SUBJECT: Triangle Expressway Southeast Extension (Complete 540) from NC 55 Bypass in Apex to US 64/264 (I-87) in Knightdale, Wake and Johnston Counties; Federal Aid No. STP-0540(19), STP-0540(20), and STP-0540(21); WBS Nos. 37673.1.TA1, 35516.1.TA1, and 35517.1.TA1; STIP Project Nos. R-2721, R-2828, and R-2829

From: [Alsmeyer, Eric C CIV USARMY CESAW \(USA\)](#)
To: [Ridings, Rob](#); [Thomson, Nicole J](#)
Cc: [Abi Sheffey](#); [Riffey, Deanna](#); [Matthews, Monte K CIV USARMY CESAW \(USA\)](#)
Subject: [External] RE: Complete 540, R2828, Modification 12 Request; Permit Site 41; DA# SAW-2009-02240
Date: Friday, August 4, 2023 12:52:31 PM
Attachments: [image001.png](#)
[230803_Site 41 Mod drawings_R-2828_Complete540_Wake.pdf](#)

**North Carolina Division of Water Resources
Transportation Permitting Unit
In-Field Minor 401 Water Quality Certification Modification**

Project Name/ TIP Project No.: R-2828; NC Hwy 540 Date: August 4, 2023

Modification Sketches:

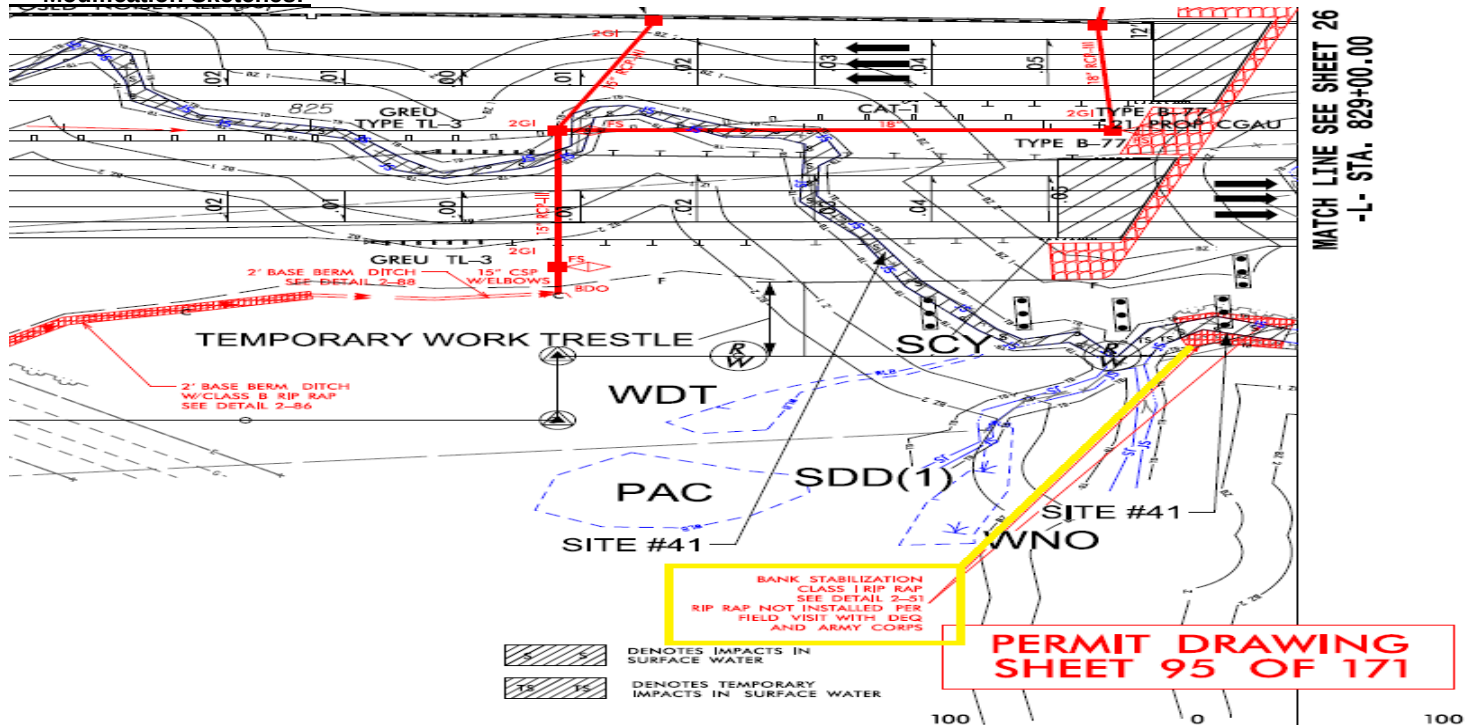
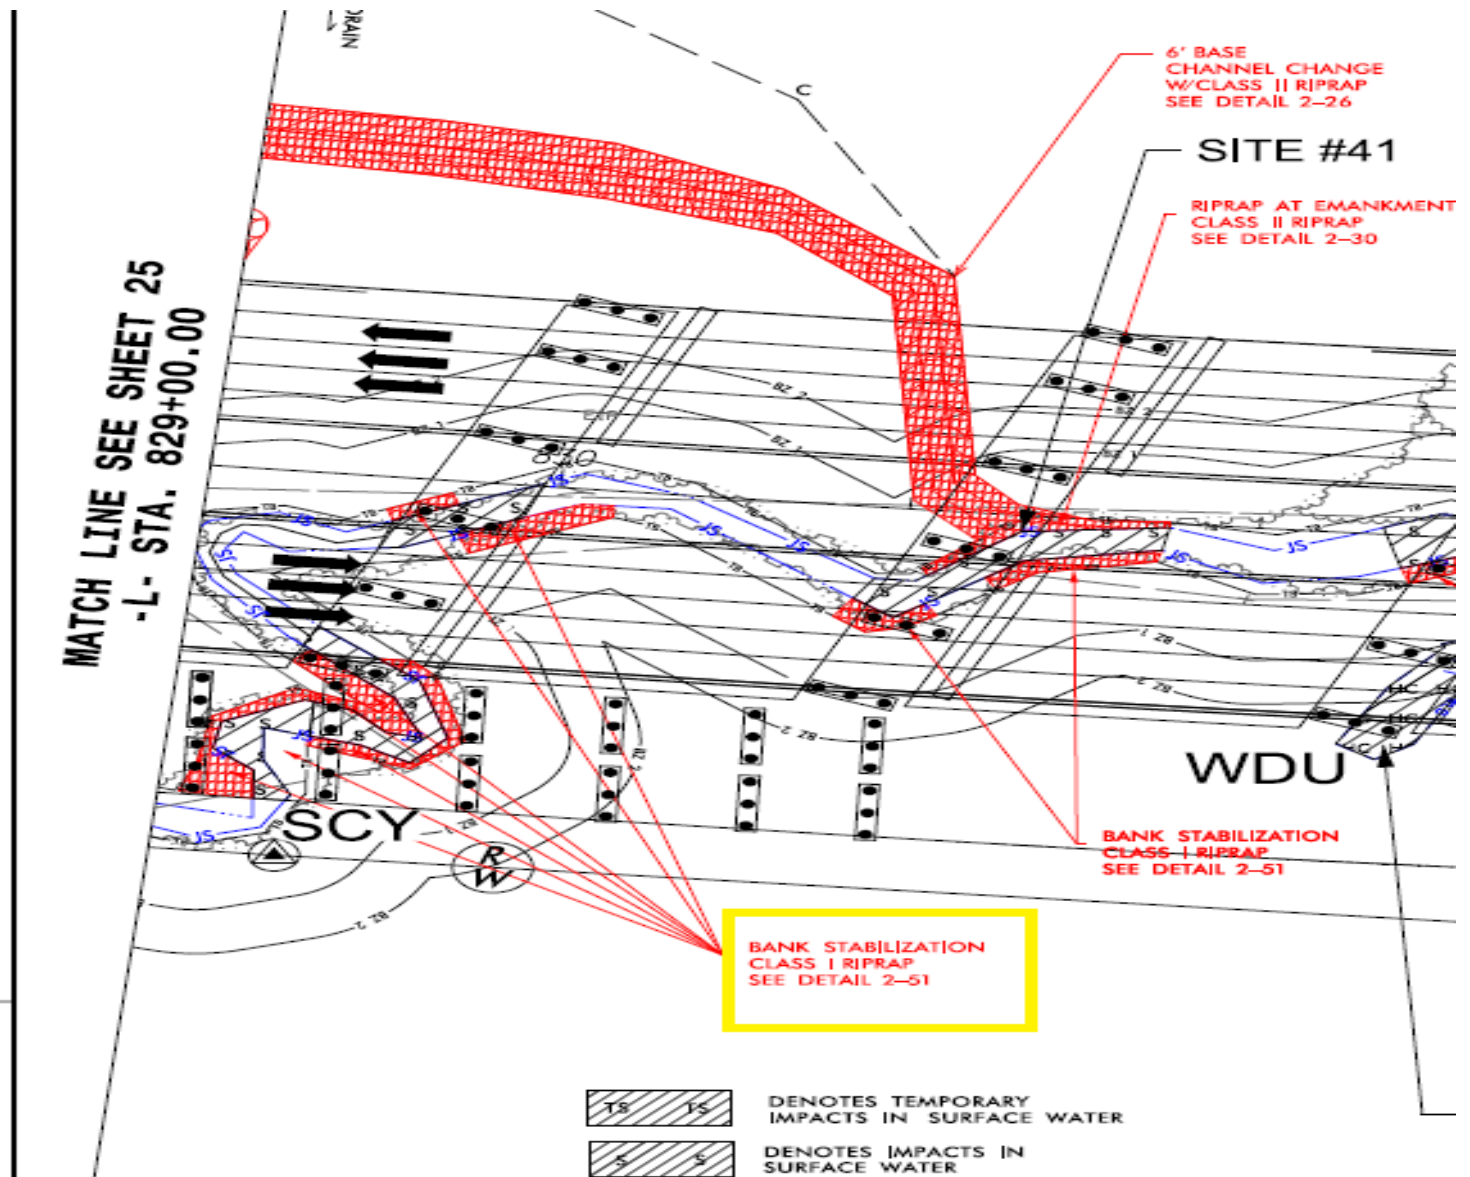
Site 41: The temporary work trestle bridge was recently removed and per an earlier agency review, some of the bank stabilization originally called for and permitted at this Permit Site were ultimately determined to not be needed (concurred upon by both of you during the agency site walkthrough). Now there is a bank location originally permitted for temporary impacts that the JV wishes to convert to permanent bank stabilization. There was significant scour realized at this bank location now that the temporary work structure has been removed, some of which was influenced by beaver activity in the area. This change was discussed agency field review July 11, 2023.

NCDOT (Turnpike Authority) formally requested in-field mod via email dated August 3, 2023. This change results in an increase in 57 linear feet of bank stabilization impact. (While results in a 57 feet decrease in temporary impact.) This impact needs no mitigation as it is not in thalweg but for bank protection.

NCTA and Agencies have concerns at Permit Site 41 regarding banks eroding underneath the temporary structures. Significant erosion has been an issue on this stream's banks.

Increase Bank Stabilization impacts by 57 linear feet, while decreasing the temporary impact by the same amount. This is for Site 41 on section R-2828 of the Complete 540 Project.
